DATE: October 7, 2009

TO: John Mousa, ACEPD

FROM: William Barnard, MACTEC
Brad Uhlmann, MACTEC

SUBJECT: Preliminary review comments on AMEC report entitled "Potential Fugitive Dust Impacts Predicted from Air Dispersion Modeling Koppers, Inc. Wood-Treating Facility Gainesville, Florida"

COMPARISON OF PARTICLE SIZE SCALES

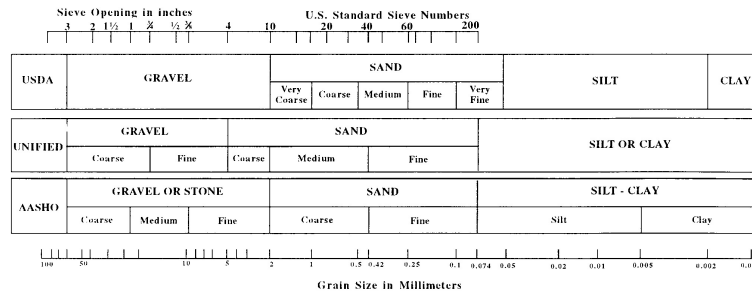
6. The AMEC assumption on page 3 that indicates that they assumed that soil silt is equivalent to the combined silt and clay fractions would lead to an *underestimate* of the silt content (as defined by EPA). The soil triangle below and the underlying sieve scale below clearly show this. Silt content on unpaved roads is measured by the fraction that passes a #200 mesh (standard size number) sieve, which is equivalent to 75 microns. The fraction that passes a #200 sieve for NRCS actually contains the clay, silt and a portion of the very fine sand fraction. Thus including only the silt and clay fraction would lead to an underestimate of the silt fraction as determined by EPA methods.
In addition, care must be used in comparing measurements of silt between EPA methods and NRCS (USDA) methods, as the methods used for determining the silt and clay fractions are different. For the NRCS method silt and clay are both determined by using wet sieving methods while the EPA silt value is determined by dry sieving. Wet and dry sieving can lead to substantially different results depending upon the type of soil being evaluated.
